# UNITED STATES PATENT AND TRADEMARK OFFICE

APPLICATION NO.	FILING DATE	FIRST NAMED INVENTOR	ATTORNEY DOCKET NO.	CONFIRMATION NO.
10/065,464	10/22/2002	Mark A. Lillis	PES-0077	5642
23462	7590	12/13/2006		
CANTOR COLBURN, LLP - PROTON 55 GRIFFIN ROAD SOUTH BLOOMFIELD, CT 06002			EXAMINER WILLS, MONIQUE M	
			ART UNIT	PAPER NUMBER

## Office Action Summary

## DETAILED ACTION

Fig. 2

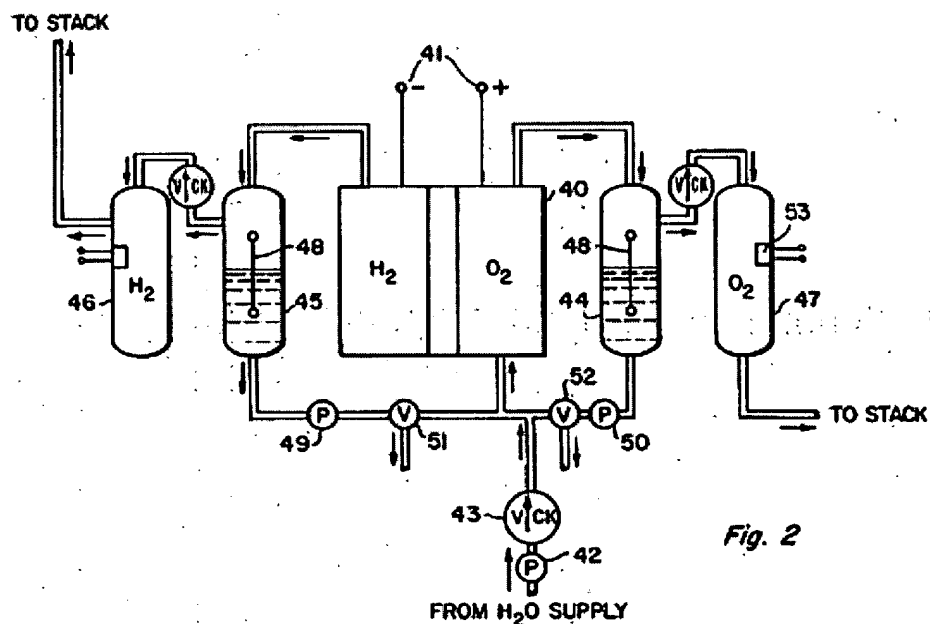
With respect to claim 4, McElroy teaches an electrochemical cell system comprising: an electrochemical cell stack (40); a fluid containment vessel (44, 45) comprising a vessel inlet in fluid communication with a stack (40) outlet; and a vessel outlet (at 50) in fluid communication with the stack (40) inlet; wherein the vessel outlet comprises an outlet control device (52). See Figure 2. As to claim 5, the system further contains a float (48) translatably disposed in the fluid containment vessel. See Figure 2.

McElroy does not expressly disclose: an inlet control device (claim 4); a load cell disposed in operable communication with the fluid containment vessel (claims 4 & 26); a second load cell (claim 2); or a load cell with a compressive force measurement device (claims 3 & 27) or tensile force measurement device (claim 4).

Therefore, it would have been obvious to one of ordinary skill in the art at the time the instant invention was made to employ the load cell of Breed in the electrochemical system of McElory to provide low cost systems using a capacitance with a liquid as a dielectric to determine the level of the liquid in the reservoir and improve accurate liquid level gage (claim 4).

Concerning an inlet control device (claim 4), it would have been obvious to one of ordinary skill in the art to employ an inlet control device to manage inlet flow to the fluid containment vessel. As illustrated in McElory, the skilled artisan practices employing flow control devices throughout electrochemical systems.
